SPECIFICATIONS - WIR J11
RHK6581 Lee Smith

This shop drawing has been examined for compliance with architectural design intent only and does not relieve either builder or subcontractor(s) from their obligations under the Contract, nor shall be deemed to be authorisation for any variation.

Kitchens By Resident Hero 32 Gateway Drive Phone: 0754471077 mark@residenthero.com.au www.residenthero.com.au	RHK6581 Lee Smith	**Scale: 1 : 20**	**Sheet 1 of 4**
	WIR J11	Do not scale off this drawing.	Drawn By:
	38 Howard St, Grange QLD		Date: 26/10/26

WIR J11 Elevation Wall 2 1 : 20

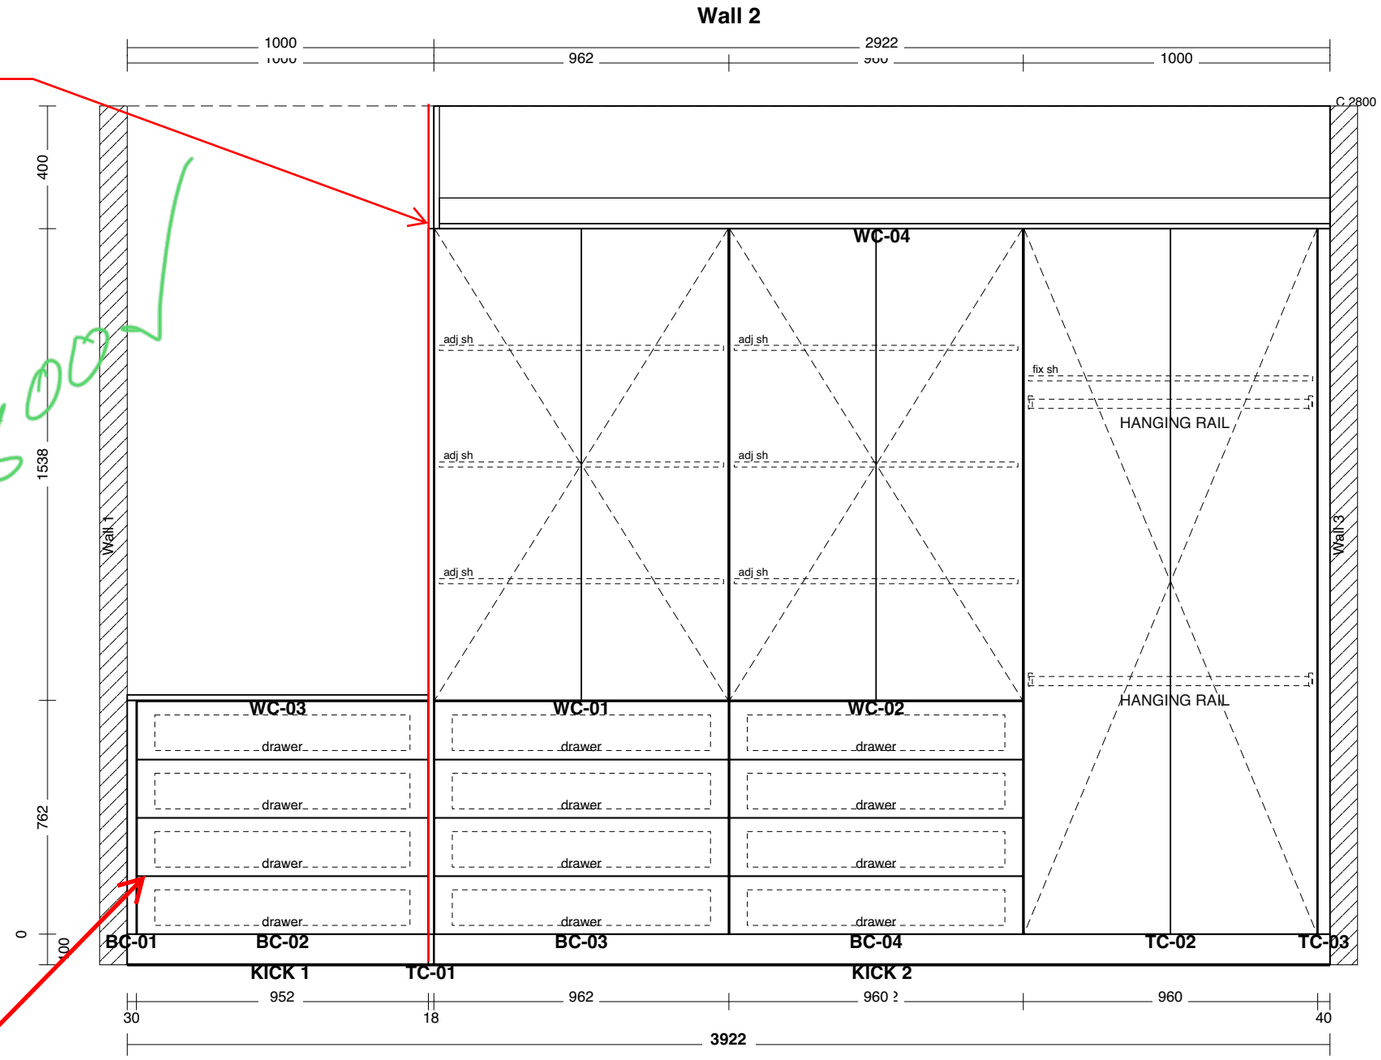
FLUSH FINISH TO EDGE OF BULKHEAD/ CABINET

50mm FILLER

WIR J11 Elevation Wall 4 1 : 20

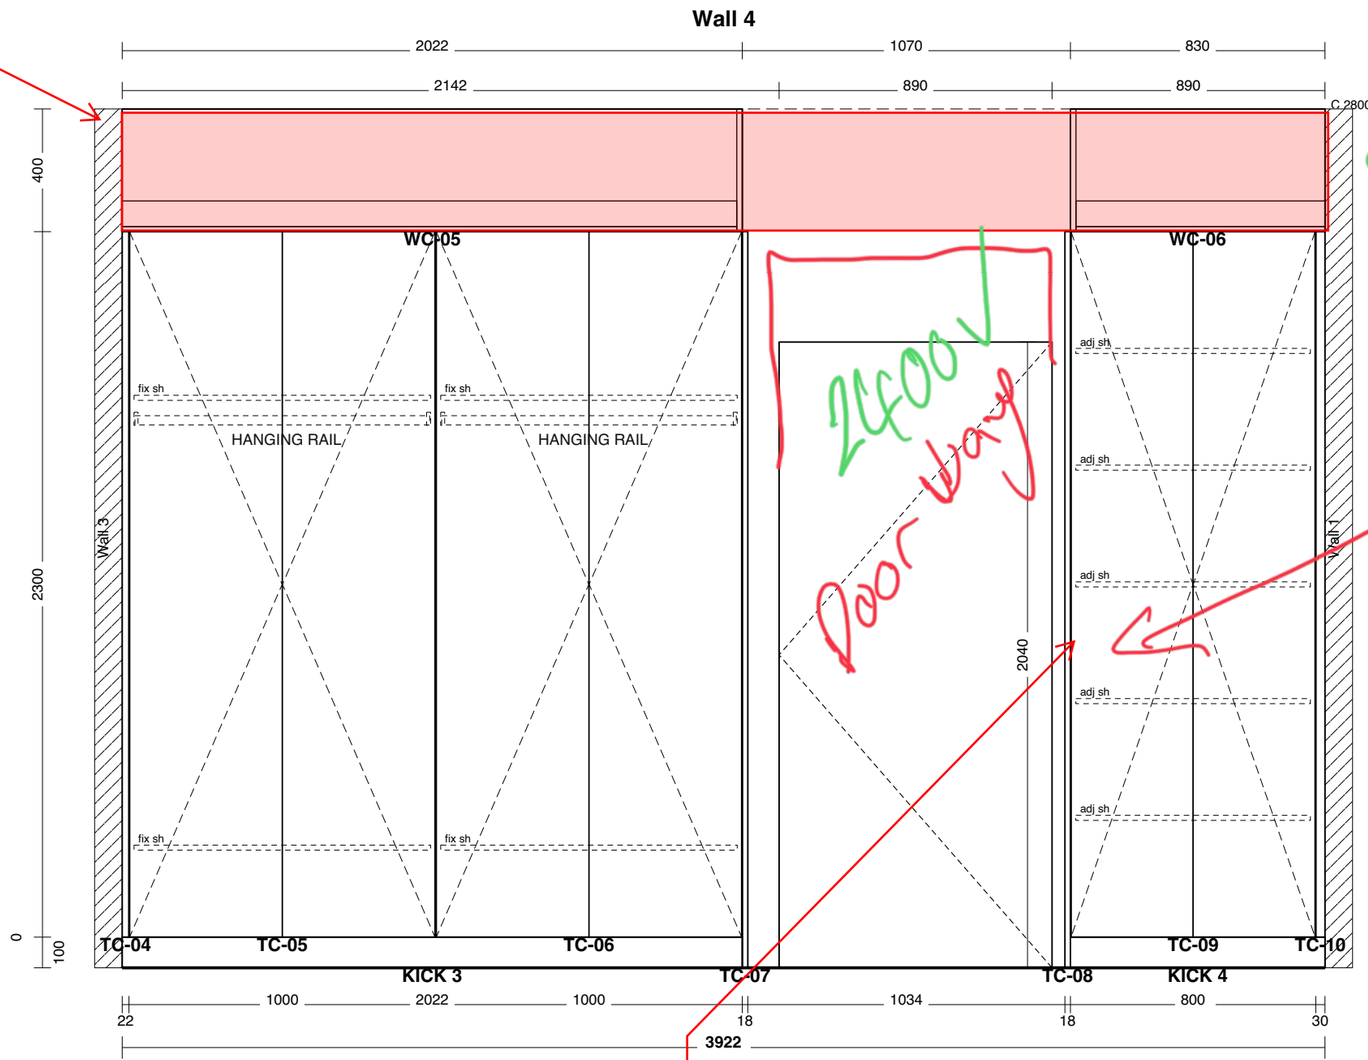
bulkhead to extend over doorway

Box out Exposed wires.

MAKE BOX AFTER - LOOSE PARTS 300mm X 100mm X 4 EDGE ALL EDGES

allow for light switch on side of this panel
